DA NO: DA-2021/5/B

ADDRESS: 1A BURRA ROAD, ARTARMON NSW 2064.

PROPOSAL: SUPPLEMENTARY REPORT - MODIFICATION OF DA-2021/5 FOR ALTERATIONS TO THE APPROVED BUILDING MATERIALS, INCLUDING CHANGES TO THE EXTERNAL FLOOR FINISHES AND CHANGES TO THE LEVELS OF THE ACCESSIBLE DROP OFF ZONE AND CAR SPACE.

REPORT DATE: 13 DECEMBER 2024

Image 1: Approved tile from heritage consultant Architectural Projects’ Jennifer Hill.

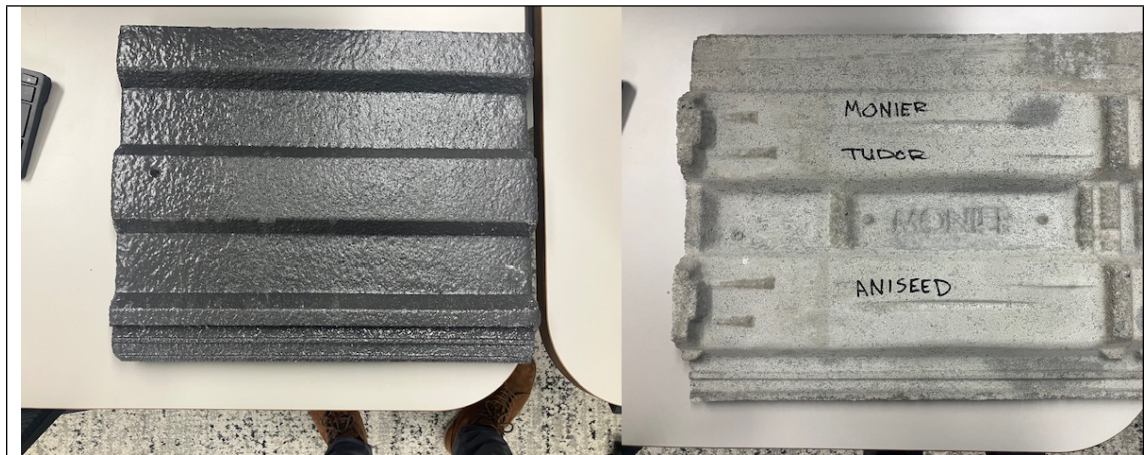
I note the following points in support of the change in roof tile:

- (a) Council’s Project Team have noted that “... the Artarmon Pavilion roof have degraded over the years. They are beyond their life” (*Senior Project Manager Thomas Gough, 2.09.2024*);
- (b) The applicant’s heritage adviser Architectural Projects (who have been involved in the project from its inception) confirms in the attached letter dated 26.08.2024, that:
“The applicant has proposed replacement of the roof tiles. Two roof samples from two companies have been provided and checked against the original roof tile. The provided ‘Tudor Aniseed’ tile is the preferred tile”. The author confirmed in letter dated 11 December 2024 (Attachment 3) that “Roof tile of Tudor Aniseed (Barramundi) is accepted and is the appropriate finish”. See image 2A below.

- *There are no issues with the change in materials on heritage grounds.*
- *Charcoal channel support is accepted. Maximum allowable spacing is 130mm.*
- *Roof tile of Tudor Aniseed (Barramundi) is accepted and is the appropriate finish.*
- *The red brick is the extension brick and is accepted*

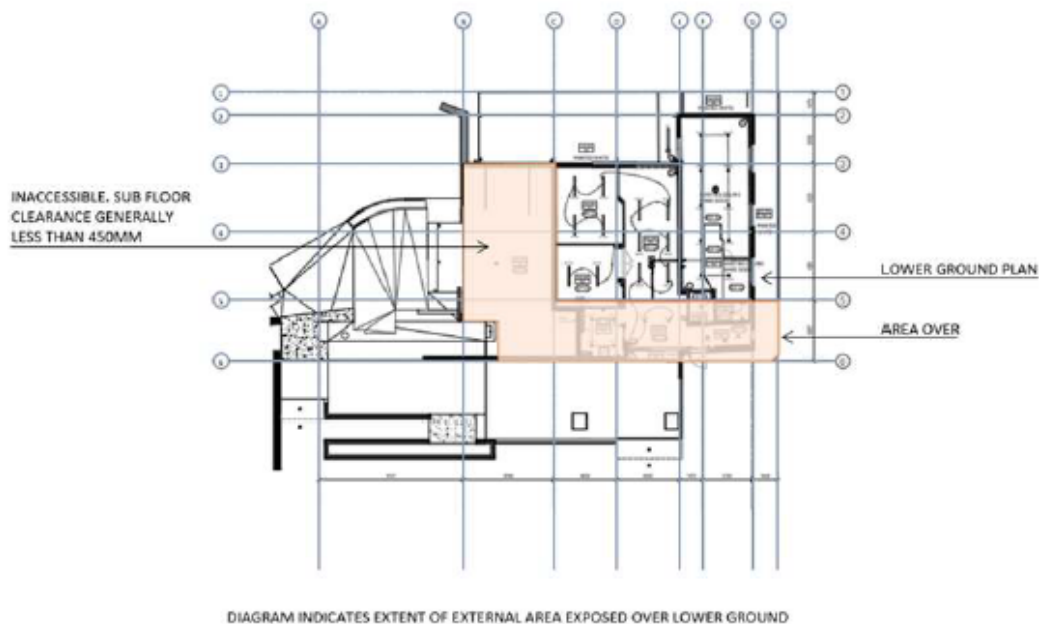
A range of alternative options have been considered in seeking a suitable outcome to address the waterproofing of the deck. These alternatives are provided in the table below. In addition to the options identified below the Contractor building the project on behalf of Council has indicated that they would not be able to warrant their work against moisture or water ingress if an open deck system were used.

The building Contractor has indicated that they are unlikely to achieve independent electrical and fire certification of the electrical switch room, being one of the ground floor spaces affected.

In summary, no viable alternative to address the performance requirements of the verandah area has been identified other than concrete.
